CITY OF ALBUQUERQUE

**RE: FNCH Wellness Center
6416 Zuni SE
Grading & Drainage Plan
Engineers Stamp Date: 04/11/2023
Hydrology File: L18D023**

Based upon the information provided in your submittal received 4/11/2023, the Grading & Drainage Plan is approved for Building Permit approval. Please attach a copy of this approved plan in the construction sets for Building Permit processing along with a copy of this letter.

ENGINEER'S SEAL DAVID SOULE 14522 PROFESSIONAL ENGINEER	FNCH WELLNESS CENTER 6416 ZUNI SE GRADING AND DRAINAGE PLAN	DRAWN BY: WCWJ DATE: 4-10-23 20230017-LAYOUT-4-10-23
4/11/23 P.E. #14522 DAVID SOULE	RIO GRANDE ENGINEERING PO BOX 93924 ALBUQUERQUE, NM 87199 (505) 321-9099	SHEET # — JOB # 20230017

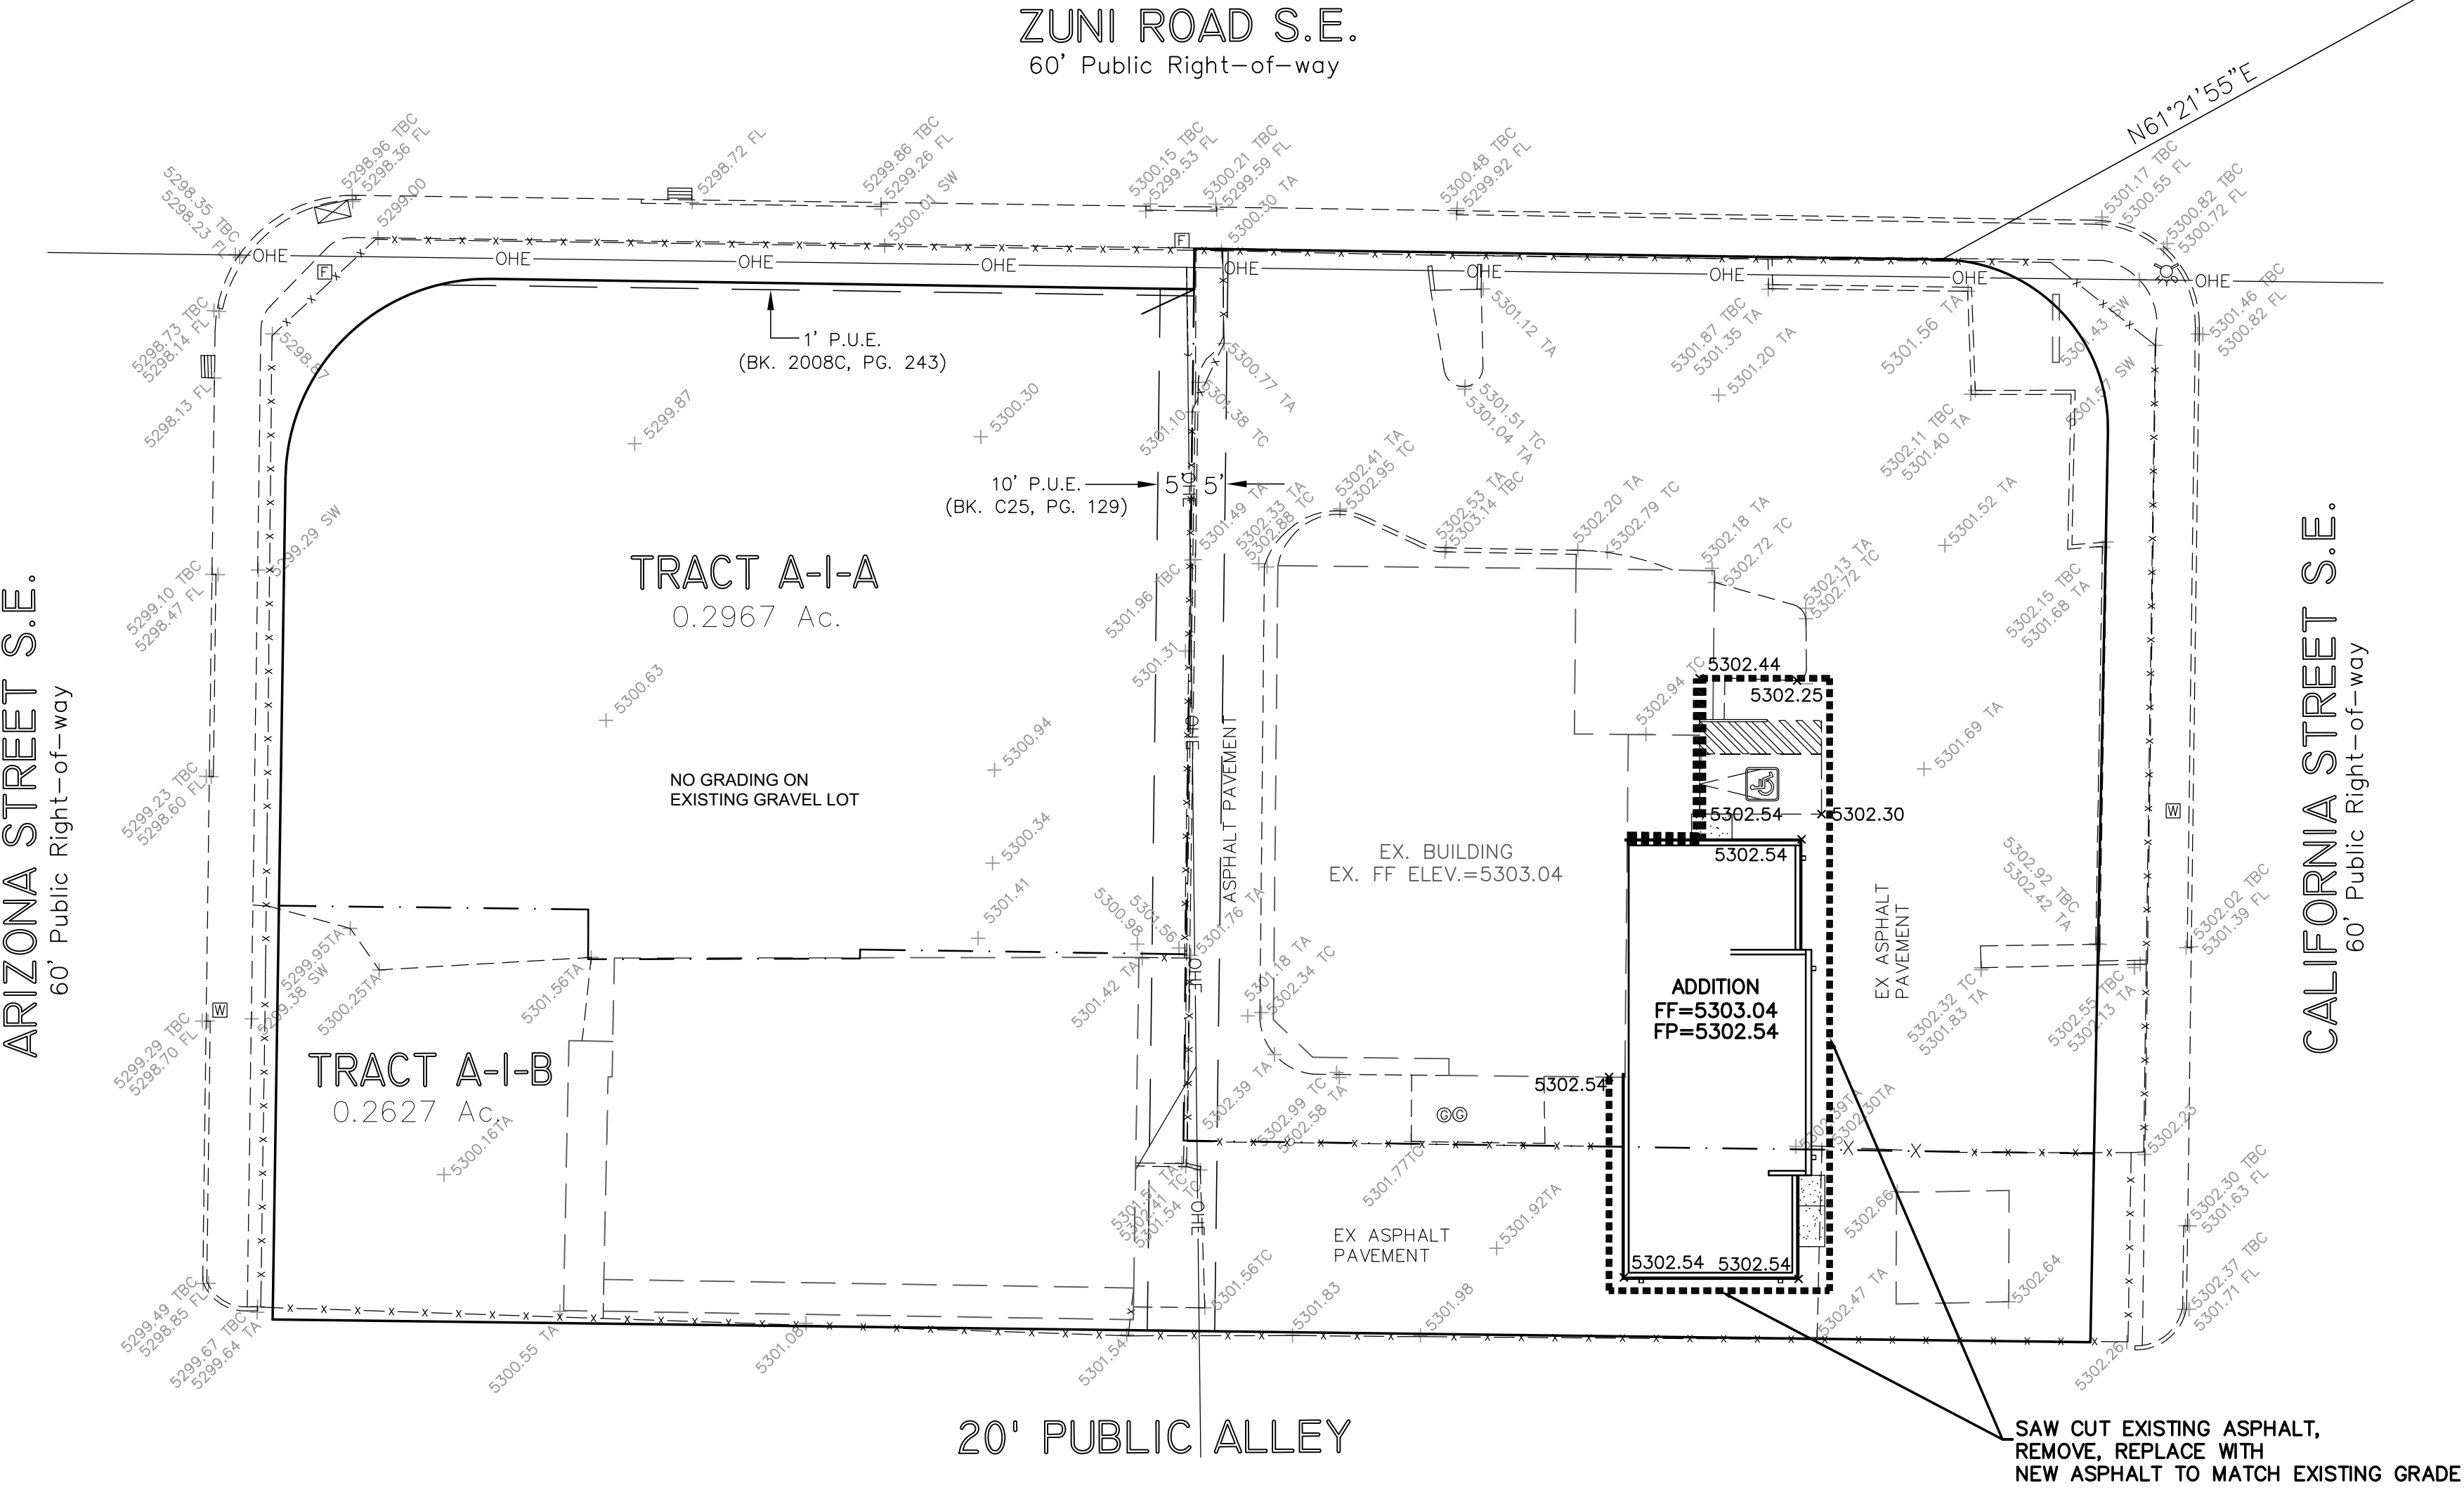
- Engineer's Certification, per the DPM Part 6-14 (F): *Engineer's Certification Checklist For Non-Subdivision* is required.
- Please pay the Payment-in-Lieu of \$ 408 by emailing the attached approved Waiver Application from Stormwater Quality Volume Management On-site to PLNDRS@cabq.gov. Once this is received, a receipt will then produce and email back with instructions on how to pay online.
